Proposed Community Preschool and Primary School - Noise Impact Assessment

1 Rosemead Road, Hornsby, NSW 2077.

January 2020

PEER REVIEW

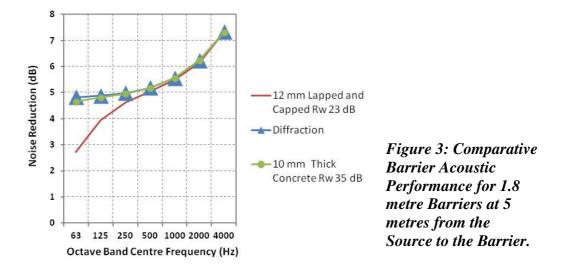
The sound attenuation of noise barriers, fences or screens can be calculated using the International Standard ISO 9613-2 (1996(E)) 'Acoustic - Attenuation of sound during propagation outdoors Part 2 General method of calculation'. Factors required for the calculation are source to barrier distance, receiver to barrier distance, screen height, source height, receiver height and barrier width. For children in outdoor play areas the source to barrier distance is highly variable, however this is taken as a distance from the central play area to the residential boundary. In any case, this distance must be consistent with the geometric divergence used in Tables 1 and 2 above; hence 20 metres is used. The calculated results show that, for a 1.8 metre high barrier the acoustic noise reduction performance is not dependent upon the weighted sound reduction index (R_w) but on the diffraction (i.e. the sound level going over the barrier). Hence for a typical lapped and capped fence with an R_w of 23 dB (in the octave band centred on 1000 Hz - i.e. typical children sound frequency) the actual performance will be less than 5 dB. If the barrier was a 10 mm thick concrete wall with a weighted sound reduction index (R_w) of 37 dB (in the octave band centred on 1000 Hz) the actual performance will still be less than 5 dB. See Figure 2 below.

If it is assumed in the unlikely case that all of the children are only 5 metres from the barrier the actual performance will be less than 6 dB in the typical children sound frequency octave band centred on 1000 Hz as shown in Figure 3 below.

In addition, the effect of geometric divergence would reduce by 12 dB from 26 dB (i.e. $20 \log_{10} (20/1) dB$) to 14 dB (i.e. $20 \log_{10} (5/1) dB$).

Figure 4: Predicted Noise Levels for the Proposed Outdoor Play Area at two Neighbouring Premises with 1.8 metre Barriers, Compared to a Typical Background Noise Level.

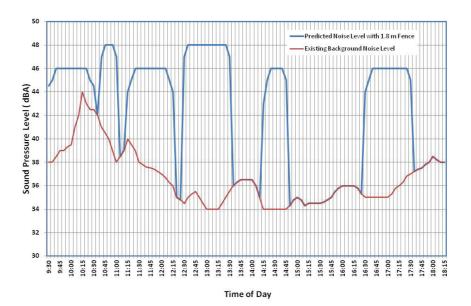
It is shown in Tables 1 and 2 above that the noise level ($L_{Aeq, 15 \text{ minutes}}$) at neighbouring premises are 51 dBA to 53 dBA without taking proposed acoustic fences into account. In section 6.2 it is shown that the proposed 1.8 metre high fence will provided just less than 6 dB overall noise reduction. This noise reduction is regardless of the weighted sound reduction index (R_w) and is due to limitations of diffraction. Therefore the actual noise level at neighbouring premises is 45 dBA to 47 dBA taking proposed acoustic fences into account. This noise level could occur for the proposed day time periods which are in excess of 4 hours as shown in Figure 4 below.

Hence the noise criteria to be applied in this case should be 5 dB and not 10 dB over the existing background noise level of **37 dBA** therefore **42 dBA**. The predicted 15 minute average noise from the outdoor play area without a noise barrier is **53 dBA** which exceeds the 42 dBA noise goal at the most affected residential properties (i.e. 1A Rosemead Road and 52 William Street) by **11 dBA** without a noise barrier. The highest predicted 15 minute average noise level ($L_{Aeq, 15 \text{ minute}}$) from the outdoor play area with the proposed 1.8 metre high fence is **48 dBA**. which exceeds the 42 dBA noise goal at the most affected residential properties by **6 dBA** with a noise barrier. When the existing background noise level is low, at say 1.00 pm, the predicted noise level from the outdoor play area will exceed the background noise level by 14 dBA as shown in the Figure 4 below.
